Sales Order: 11578-F	Custom Metal Bench	
Item: n/a	No. B-1420-6-SM-HCC	
Finish: Gun Metal Powder Coat	<input type="checkbox"/> approved <input type="checkbox"/> approved as noted <input type="checkbox"/> not approved revise as noted	Date 10.16.20 BY MBC Scale 3/32" = 1"
Other: n/a		
PHONE: 540.342.1548	FAX: 540.342.1417	WEB: RCLFINC.COM

Top View

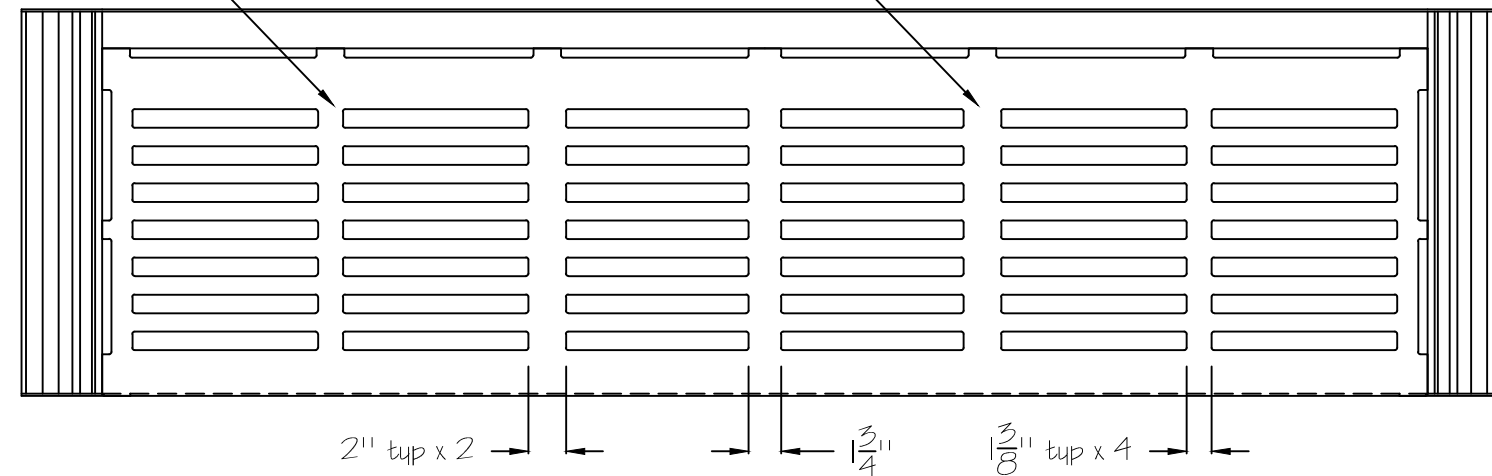
This area of pattern must be bridged in Seat to support weight when sat on

Rectanqular pattern in Seat aligns with pattern in Back

Arm Slats flush with outer contour of Arm

Arm Slat Detail

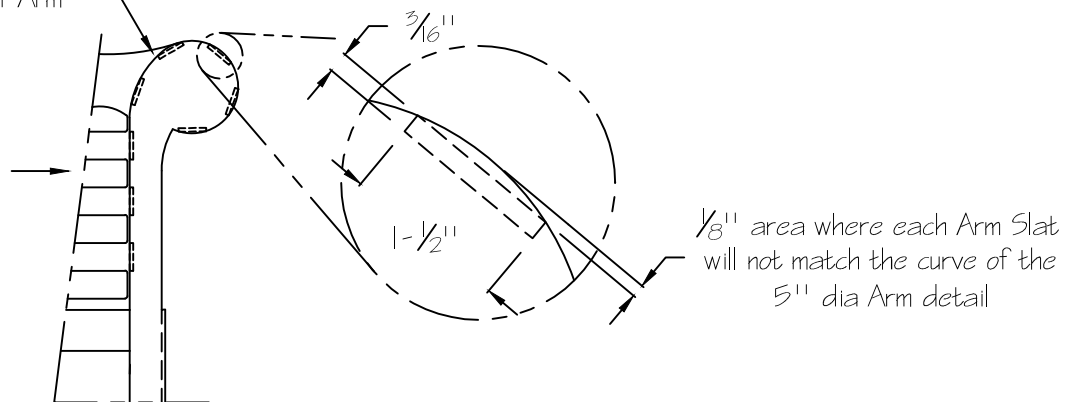
Arm Slats align with closed areas of bench back
